CITY OF STAR

LAND USE STAFF REPORT

FILE(S) #: FP-24-02, Final Plat, Naismith Commons Subdivision Phase 3

The Applicant is requesting approval of a Final Plat for Naismith Commons Subdivision Phase 3, consisting of 25 residential lots and 2 common lots on 10.72 acres. The subject property is located at 8895 W. Joplin Road in Star, Idaho, Idaho. Ada County Parcel Number are S0419325800 & S0419314950

Approved
Preliminary Plat

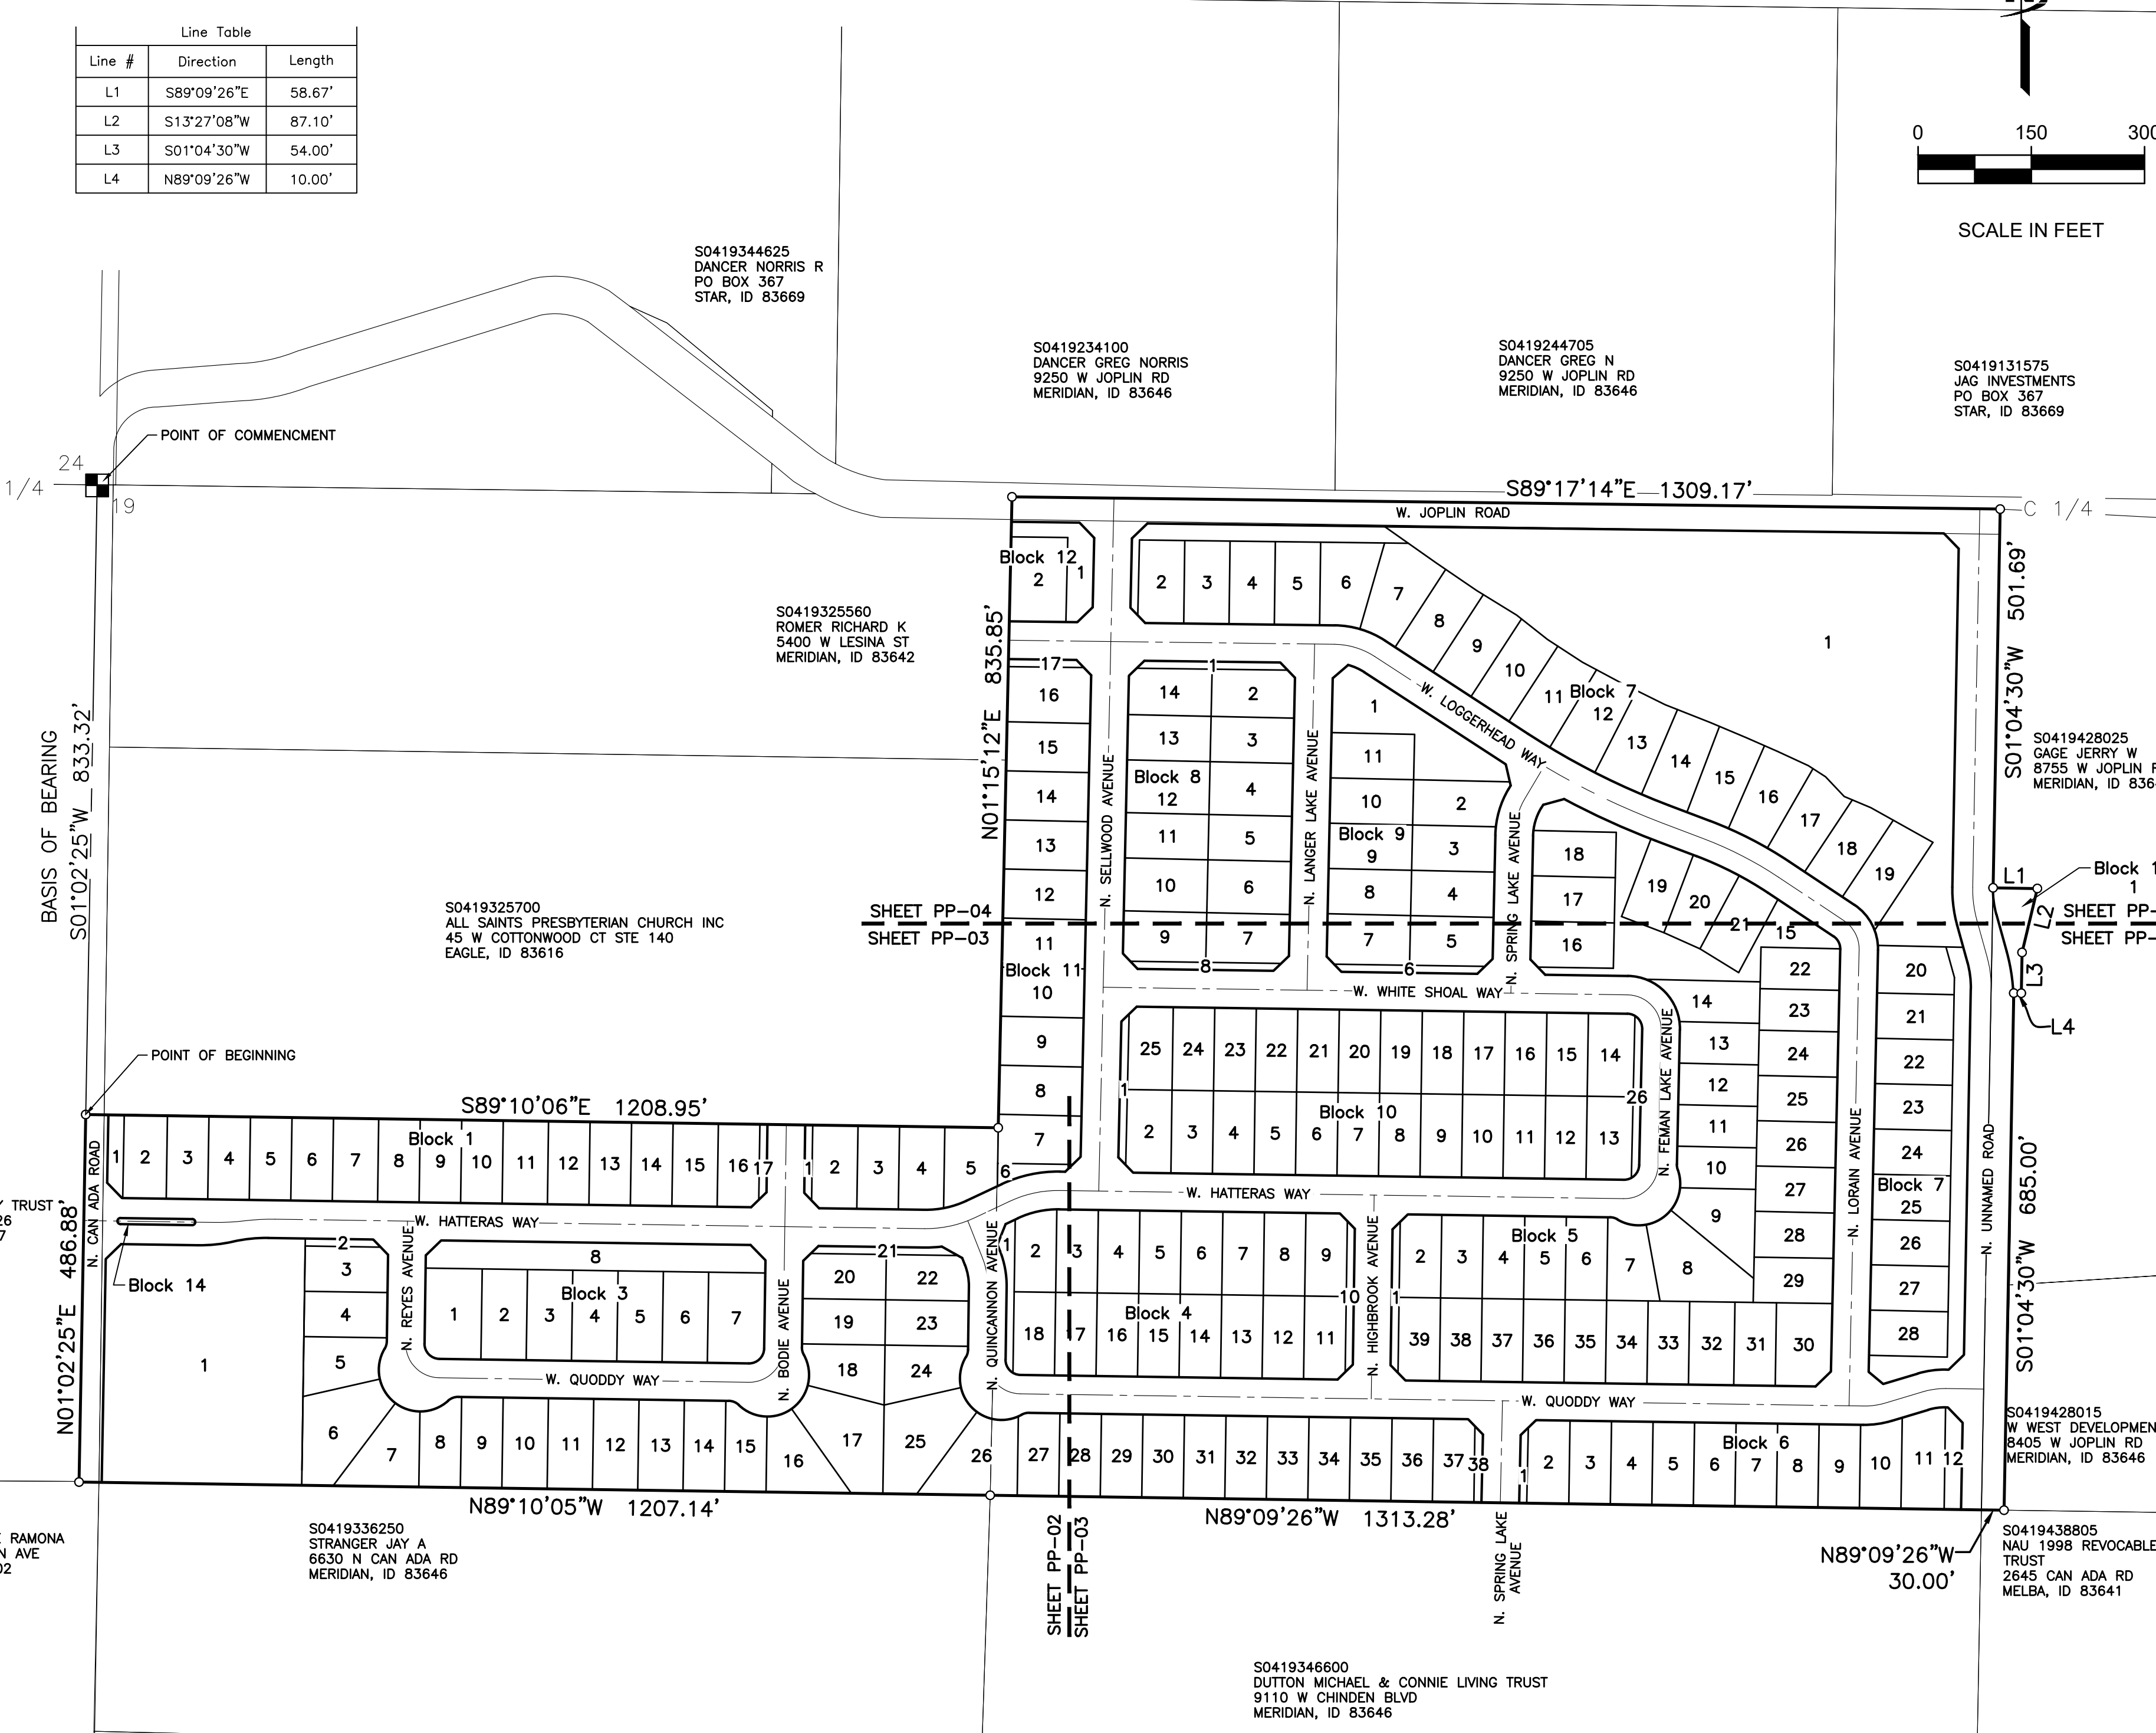
Council added a condition of approval to the Preliminary Plat (Condition 6a) requiring the following: "The Applicant shall deed Lot 1, Block 13 of the Preliminary Plat to the neighbor to the east. This shall occur upon recordation of the Final Plat that includes this lot and prior to issuance of first residential building permit". Plat note 8 of the Final Plat

states that Lot 2, Block 9 (previously Lot 1, Block 13 of the preliminary plat) shall be owned and maintained by the HOA. This is in direct violation of the condition of approval. The applicant shall revise the Final Plat note to recognize that lot as a dedicated lot. The applicant shall provide Staff with proof of dedication of the lot to the neighbor prior to signature of the phase 3 of the Final Plat.

- E. Provide a revised final plat showing the correct recognition of Lot 2, Block 9 as being dedicated to the neighbor to the east. A copy of the recorded deed shall be submitted to Staff.**

Proposed Landscaping of N/E Park

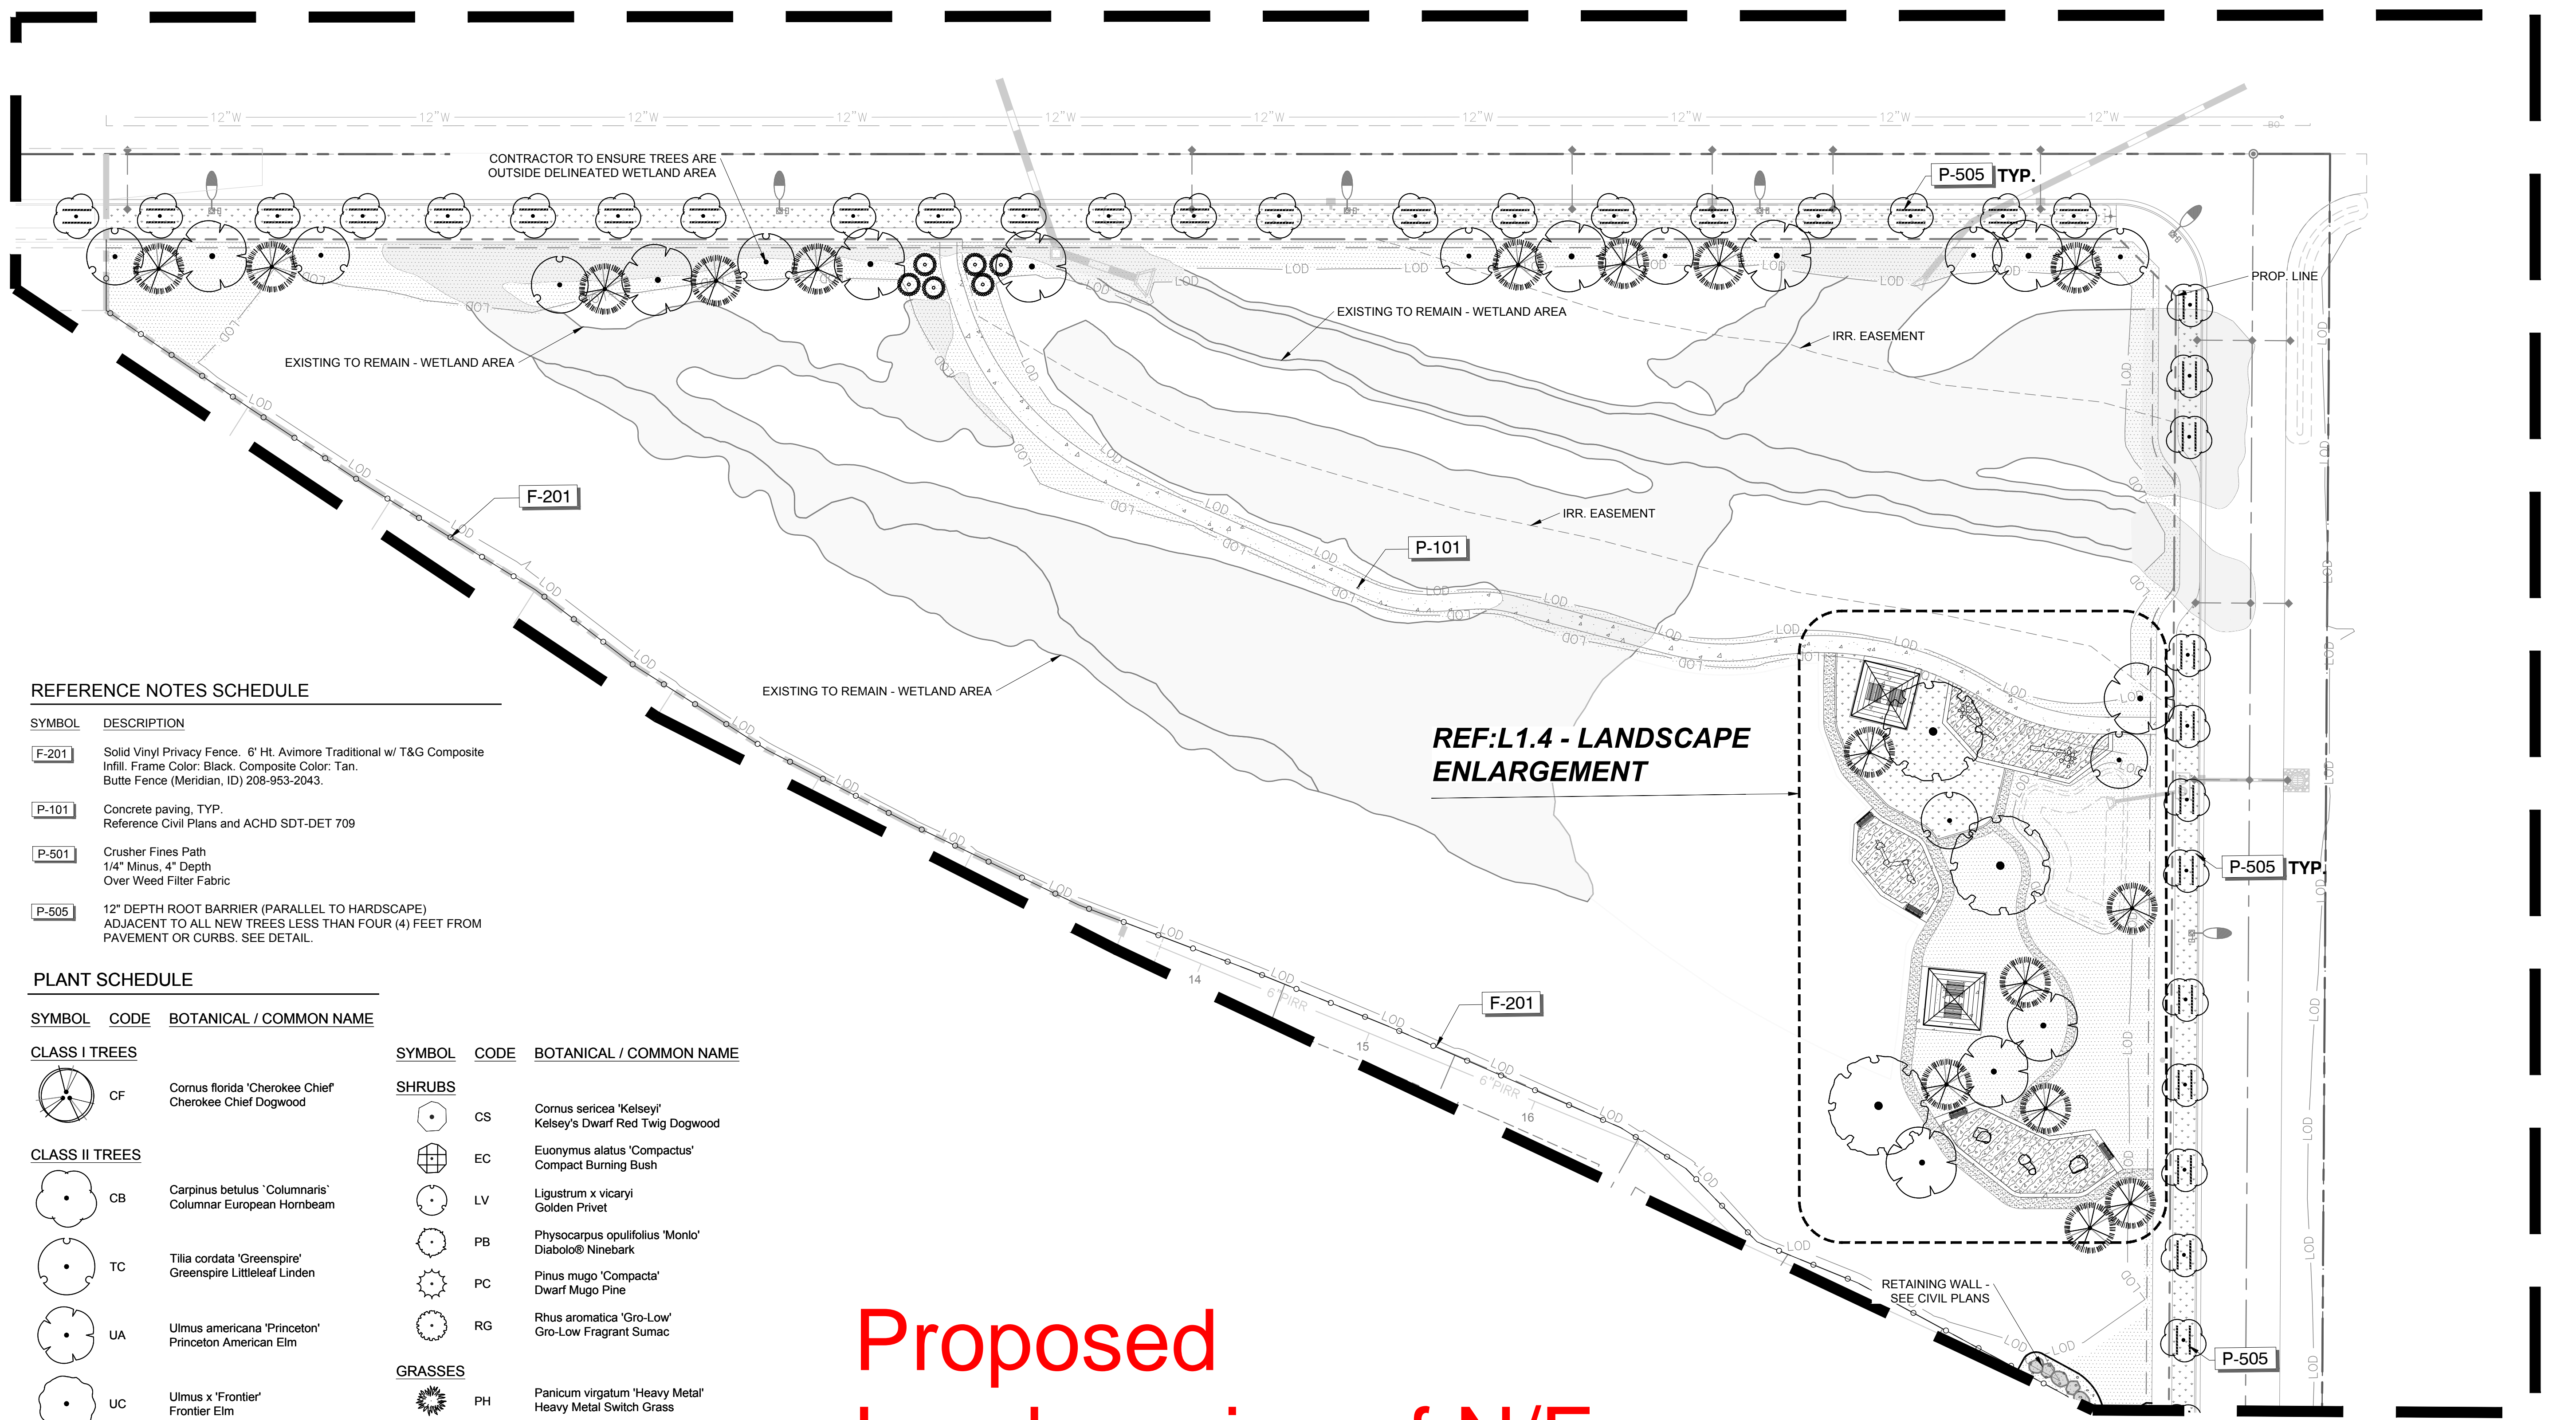
The landscaping and amenities within the park located in the northeast corner of the site do not match the approved landscape plan that was part of the preliminary plat. However, the applicant’s representatives identified federally regulated wetlands and a 90-foot Eureka Water Company easement that does not allow for any development in those areas. The applicant has provided staff with a breakdown of the original amenity plan with the revised plan based on the recent constraints. Staff finds that the intent of the original approval has been met with the revised plan.

- F. Provide a public access easement on the pathways located in the northeast common area park.**
 - G. Applicant shall provide written documentation for City to take over ownership of southwest park in the future. The recorded CC&R's shall recognize this, and a copy shall be provided to Staff.**
